CITY PLANNING COMMISSION

APPLICATION: A. Variance to reduce the front yard setback from 25 feet to one foot for a carport trellis (Sec. 3-B)

B. Variance to construct a four-foot fence in the public right-of-way (Sec. 3-B)

LOCATION: 4323 'G' Street

SITE PLAN 15-10	
1444 RESIDENCE 1955 - 2nd STREET	
E. A. G.	
ARCHITECT

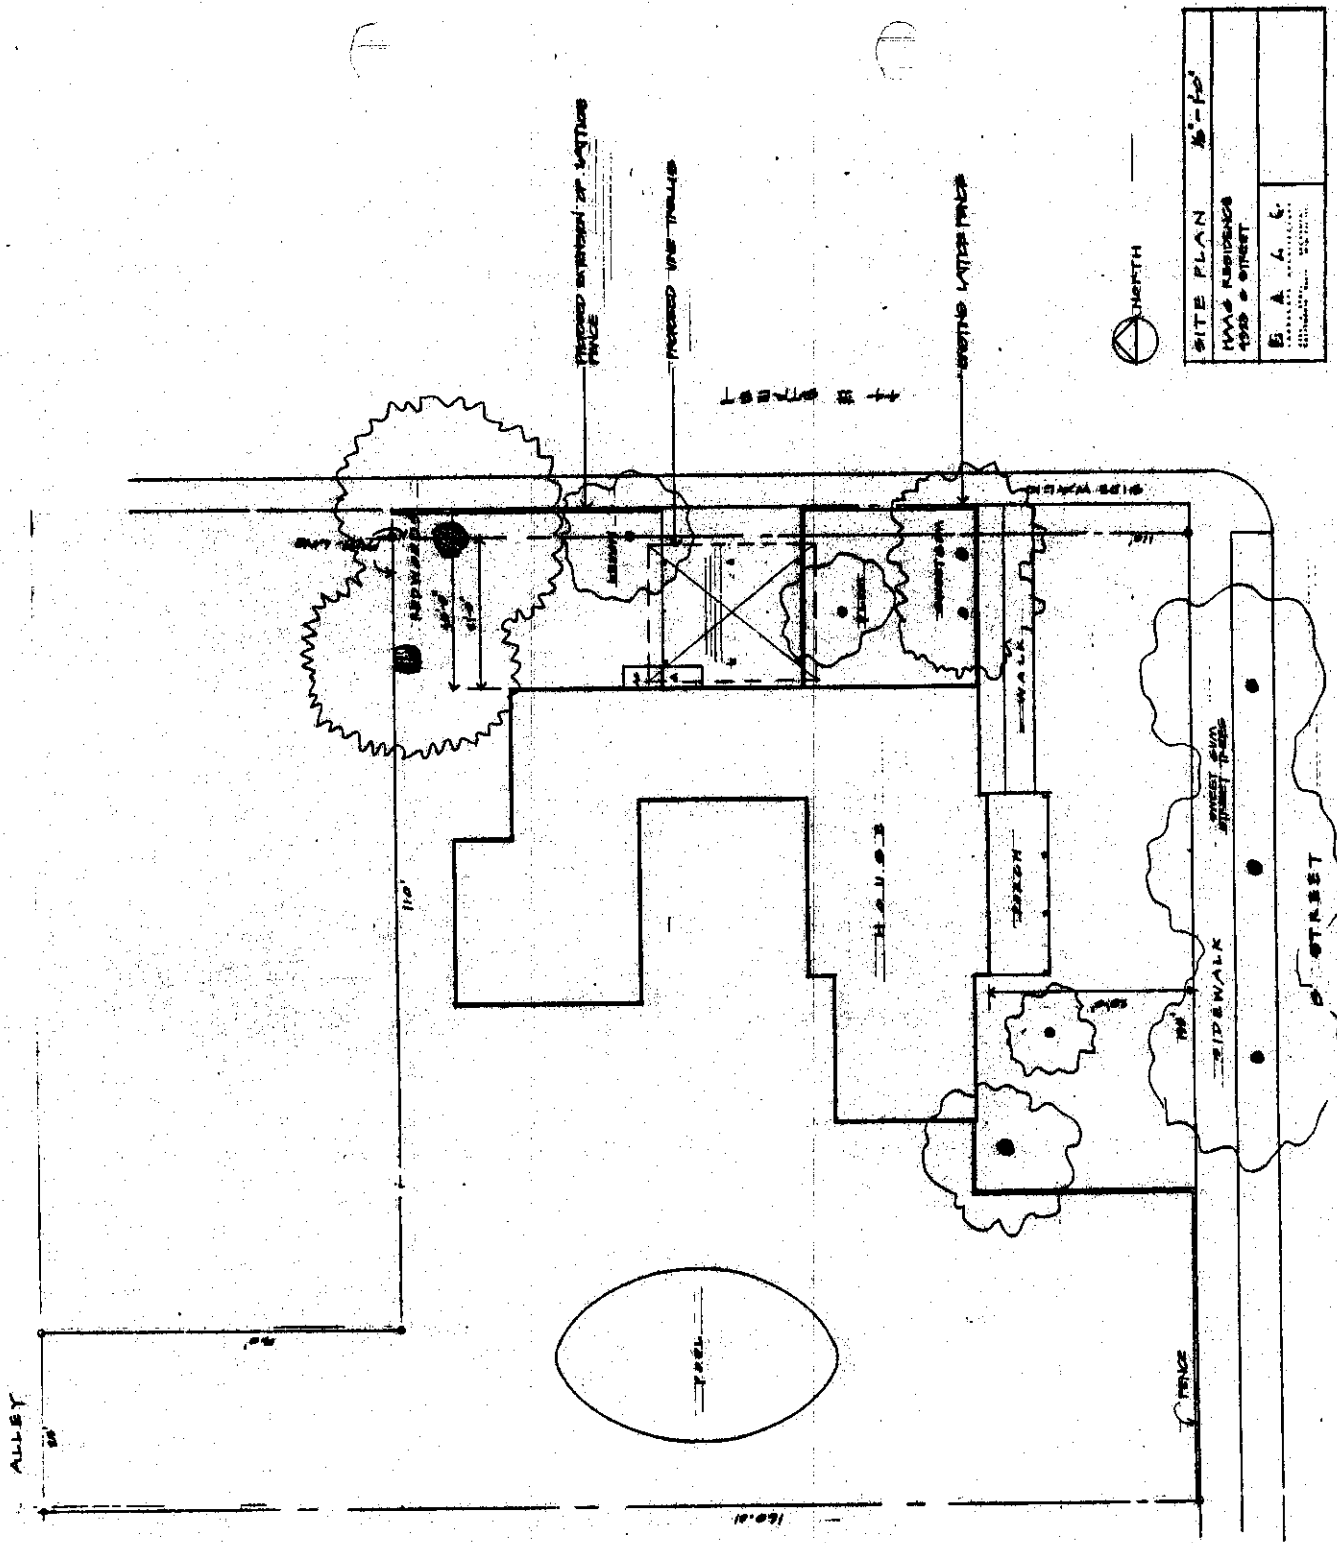
- B. The applicant is requesting to locate a carport trellis over an existing driveway within one foot of the front property line. The applicant's plans also indicate that a four-foot high fence is proposed to be located within the public right-of-way adjacent to the front property line on the north side of the proposed trellis. As proposed, staff cannot support the applicant's request since adequate space and street or alley access is available on the site to develop covered parking. Staff is also concerned that the variance, if granted, would disrupt the character of the neighborhood by interfering with the open space along the street.

- C. The City Traffic Engineer reviewed the applicant's proposal and indicated that a revocable encroachment permit will be required for the proposed fence. This fence is also in excess of the maximum allowable height of three feet. Since the neighborhood has not experienced a high incidence of crime and the fence is not necessary for security purposes, staff can find no hardships which warrant the requested variance.

- A. Denial of the variance to reduce the front yard setback from 25 feet to one foot, based upon the following Findings of Fact;
- B. Denial of the Variance to allow a fence in excess of three feet in the public right-of-way, based upon the following Findings of Fact.
